RE: Request for Minor Project Modifications for DEP#204-0991, The Reconstruction of Foster Street in Littleton, MA.

PLAN MARKUP SHOWING PROPOSED CHANGES TO LEACHING CATCH  
BASINS

LITTLETON  
RECONSTRUCTION OF FOSTER STREET

DRAINAGE & UTILITY PLANS

| STATE                   | FED. AID PROJ. NO.     | SHEET NO. | TOTAL SHEETS |
|-------------------------|------------------------|-----------|--------------|
| MA                      | STP/CMQ/TAP-0033(037)X | 62        | 128          |

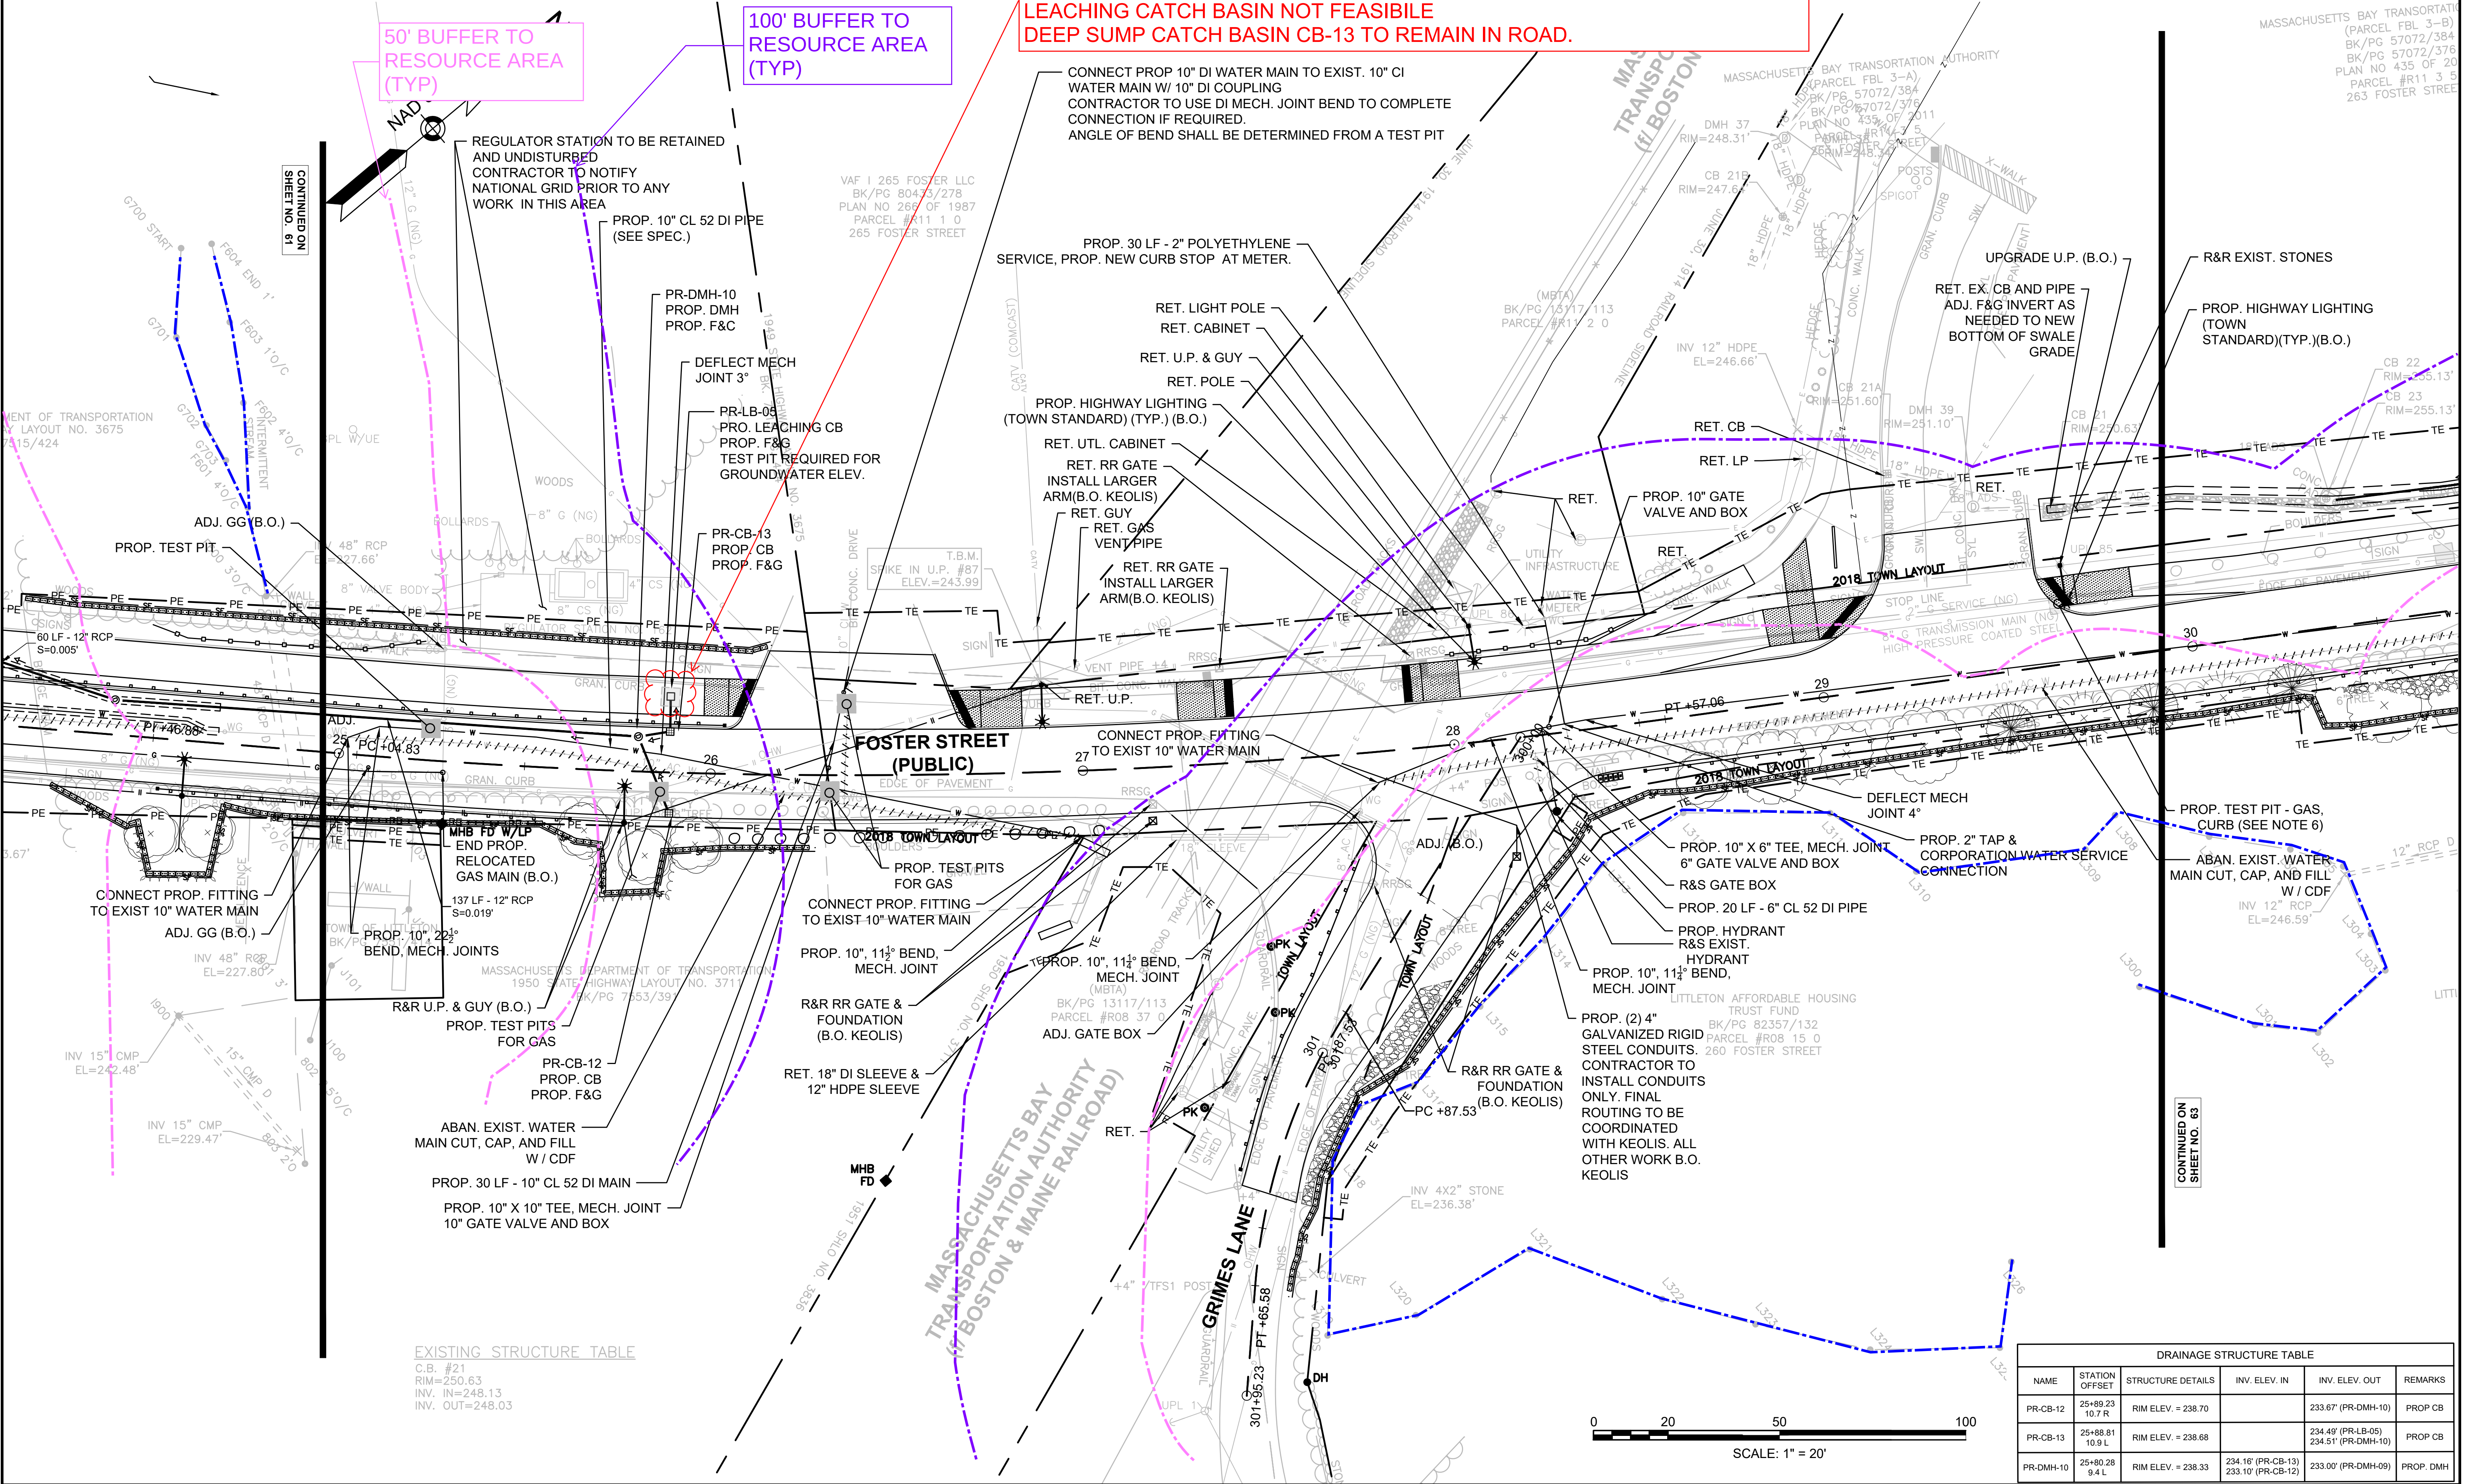
LOCATION OF LEACHING BASIN-04  
ESTIMATED SEASONAL HIGH GROUND WATER DEPTH 2.7' BELOW SURFACE  
LEACHING CATCH BASIN NOT FEASIBLE  
DEEP SUMP CATCH BASIN CB-08 TO REMAIN IN ROAD.

| <del>PR-LB-04</del> | <del>22+59.72</del><br><del>20.1 L</del> | <del>RIM ELEV.</del> |

| STATE            | FED. AID PROJ. NO.     | SHEET NO. | TOTAL SHEETS |
|------------------|------------------------|-----------|--------------|
| MA               | STP/CMQ/TAP-0033(037)X | 64        | 128          |

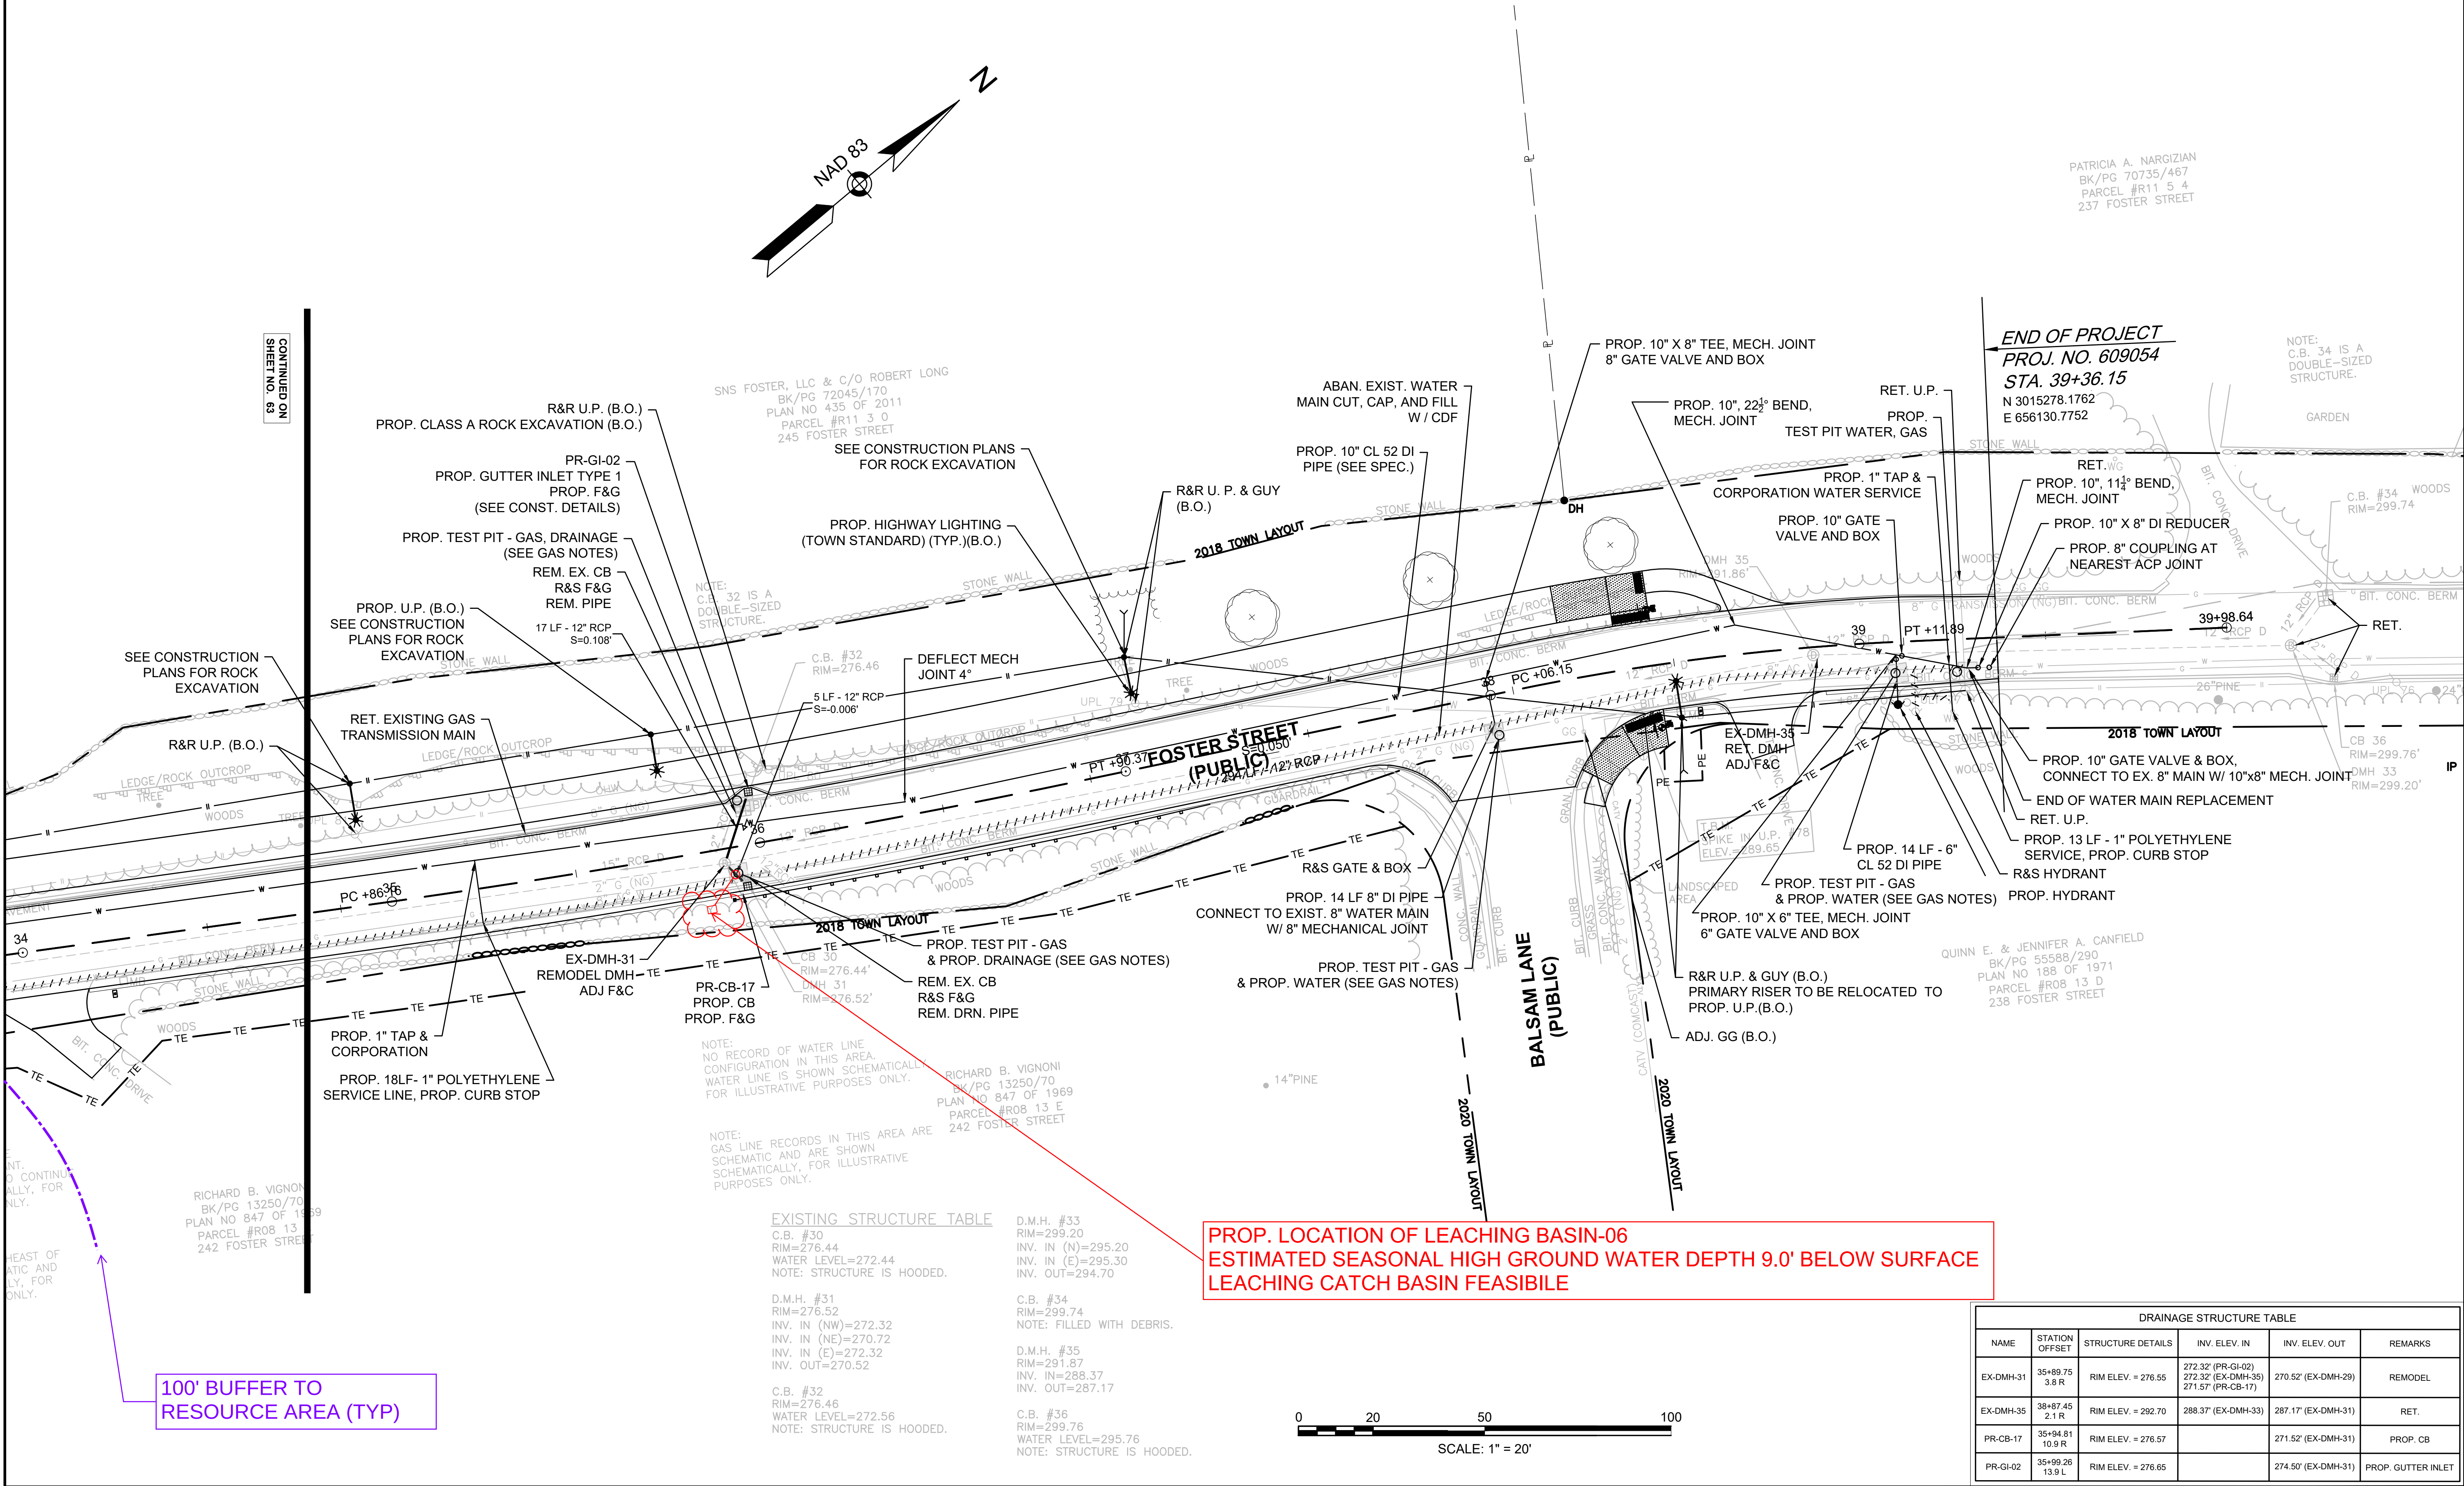
PROP. LOCATION OF LEACHING BASIN-06  
ESTIMATED SEASONAL HIGH GROUND WATER DEPTH 9.0' BELOW SURFACE  
LEACHING CATCH BASIN FEASIBLE
